**Technical Service
Information Bulletin**

Title: **ENGINE IDLE KNOCK NOISE**

Models: **'07 LS 460/460L**

**ENGINE
EG014-07**

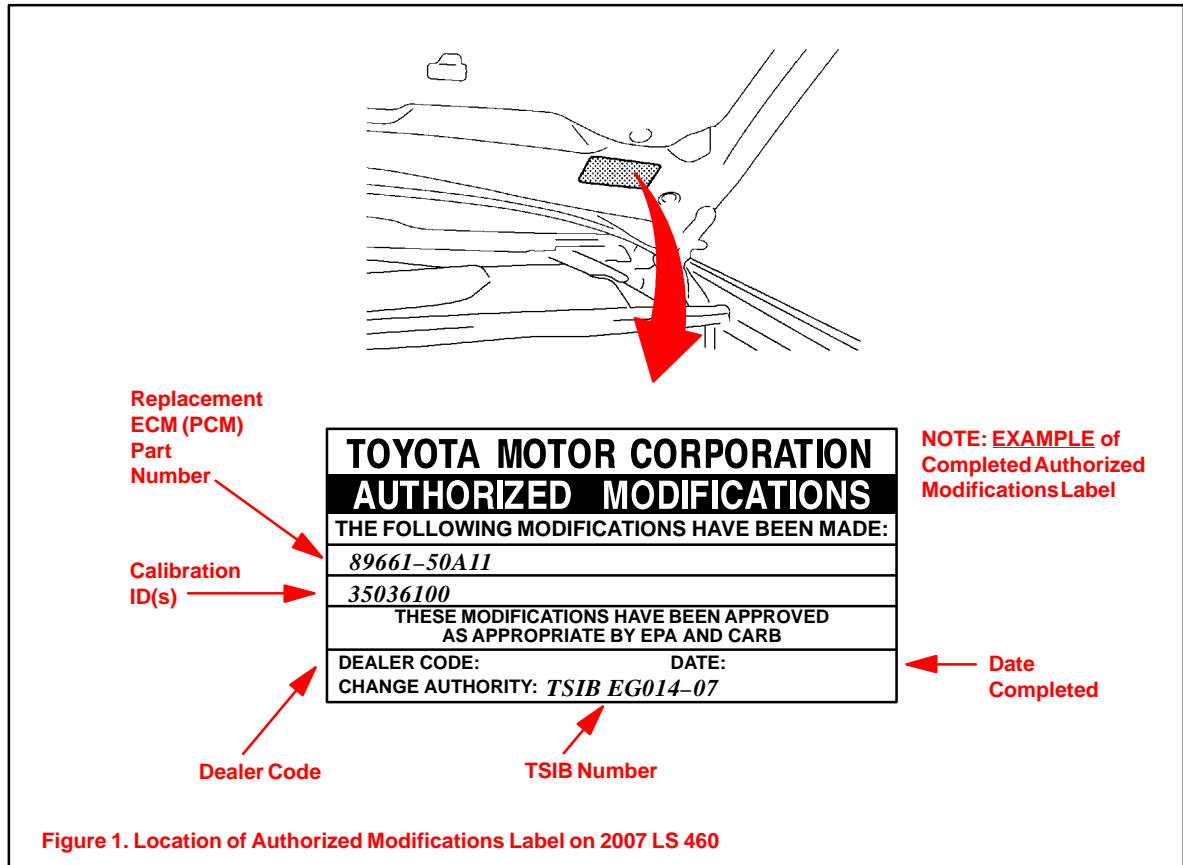
1. Check for the Authorized Modifications Label affixed to the vehicle in the location shown in Figure 1. Confirm if the ECM (PCM) calibration has been updated. If the calibration ID listed is NOT the latest ECM (PCM) calibration — go step 2. If the calibration ID listed is the latest ECM (PCM) calibration — go to Repair Procedure B.

3. Install the Authorized Modifications Label.
 - A. Using a permanent marker, enter the following information on the label:
 - ECM (PCM) part number: *[Refer to the **Parts Information** section for the **CURRENT PART NUMBER**]*
 - Calibration ID(s): *[Refer to the **Calibration Identification Chart** for the **NEW CALIBRATION ID**]*
 - Dealer Code
 - Repair Date
 - Change Authority (this TSIB number): *EG014–07*
 - B. Affix the Authorized Modifications Label to the vehicle at the location shown in Figure 1. The Authorized Modifications Label is available through the MDC, P/N 00451–00001–LBL.
4. Confirm that the ECM recalibration addressed the customer concern. If the knocking noise is gone, the repair is complete. If the noise is still present, go to Repair Procedure B.
